**STAFF REPORT: SEPTEMBER 11, 2024 MEETING**

**APPLICATION NUMBER: HDC2024-00454**

**ADDRESS: 1710 BAGLEY**

**SCOPE: REPLACE EXISTING SIDING WITH ENGINEERED SIDING**

*Photos from HDC files that show the condition of the property in August 2002, when HDC staff reviewed applications for new windows and the removal of the asphalt siding.*

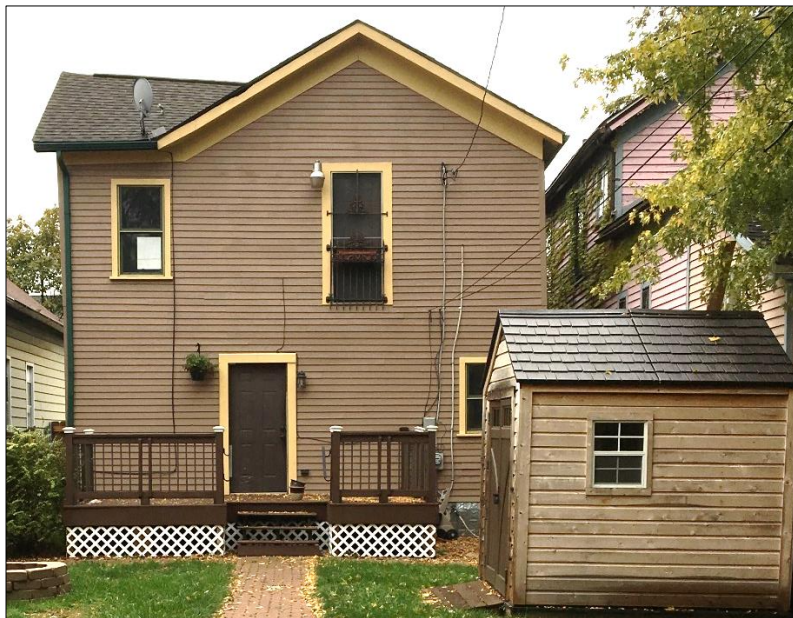
- In 2002, HDC staff approved the installation of aluminum-clad wood windows, as well as the removal of the asphalt siding. Based on existing conditions, the removal of the siding from the sides of the house was not completed.

1714 Bagley, neighboring house to immediate west of 1710 Bagley.

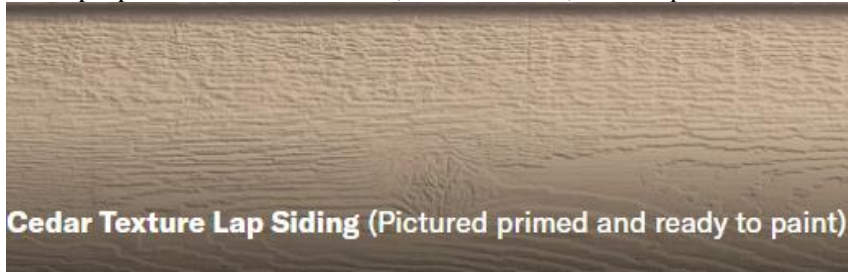
As shown in the 1710 Bagley designation photo, this house also had asphalt siding, which was removed to re-expose the original wood siding.

The wood siding originally had, and generally retains, a smooth finish. The “embossed grain” surface on some areas of the lap siding is due to the uneven finish of not fully removed multiple coats of paint that was applied over the course of 100 + years, and is an expected and authentic expression for century-old siding.

Note the generally smooth surface of the wood trim around the windows, as well as the window casing proportions. Typical window trim detail for late 19<sup>th</sup> century wood-sided houses has narrow and projecting wood sills, as shown at right.

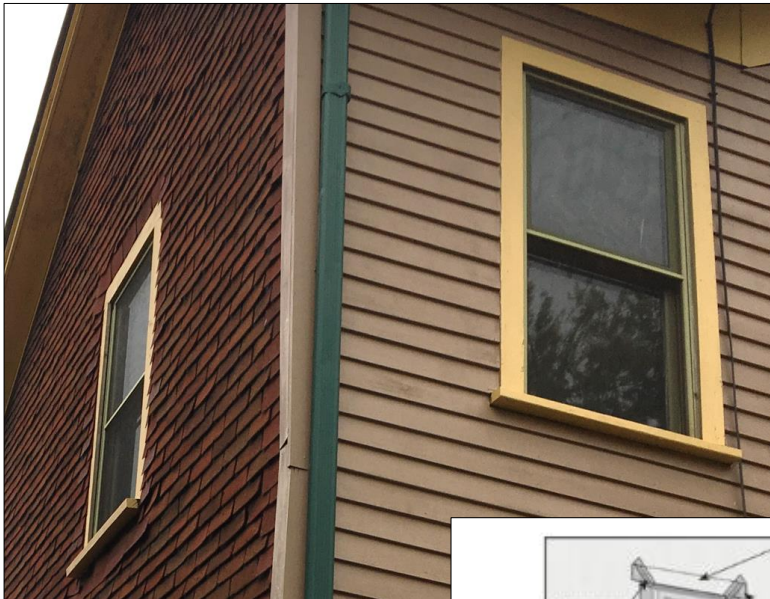
- Staff emailed the applicant and asked if an investigation at the side walls has occurred to determine if wood siding is present under the asphalt siding.
- The application proposes to remove all existing siding and install LP Smartside siding and trim. The applicant proposes the “cedar” finish, shown below, but the product does offer a “smooth” finish.

- The Certificate of Appropriateness issued in 2002 was for the installation of wood lap siding at the front elevation. It is staff’s opinion the replacement of the 20+ year old wood siding should be completed with the installation of new wood siding, as Standard Six states *“Deteriorated historic features shall be repaired rather than replaced. Where the severity of deterioration requires replacement of a distinctive feature, the new feature shall match the old in design, color, texture, and other visual qualities and, where possible, materials.”* Wood lap siding is readily available and can offer a matching texture, exposure and edge profile to historic wood siding.

- The replacement of the 20+ year old wood siding should be completed with the installation of new wood siding, as Standard Six states “*Deteriorated historic features shall be repaired rather than replaced. Where the severity of deterioration requires replacement of a distinctive feature, the new feature shall match the old in design, color, texture, and other visual qualities and, where possible, materials.*” Wood lap siding is readily available and can offer a matching texture, exposure and edge profile to historic wood siding.

Right: Installation drawing from LP Smartside website. Note the rendering and sections of the top and bottom of the window trim specify uniform height and flat profile trim.

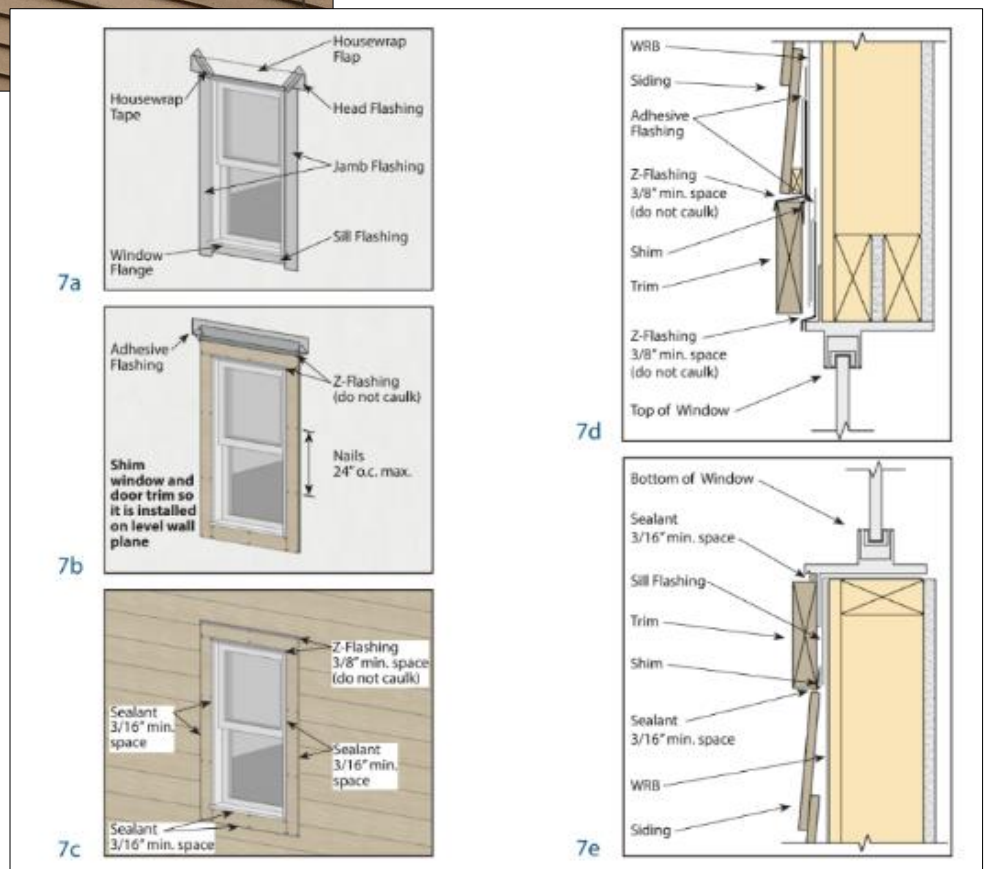
- The design and dimensionality of the window casings is a distinctive character-defining feature of the dwelling; this detail identifies the era of construction/age of the house and must be retained, or replaced in kind with new wood and painted finish.
  - The installation drawings provided by LP Smartside shows a design of uniformly dimensioned, flat window trim at the top, bottom and sides.

- The installation drawings provided by LP Smartside shows a design of uniformly dimensioned, flat window trim at the top, bottom and sides.

- The design and dimensionality of the window casings is a distinctive character-defining feature of the dwelling; this detail identifies the era of construction/age of the house and must be retained, or replaced in kind with new wood and painted finish.
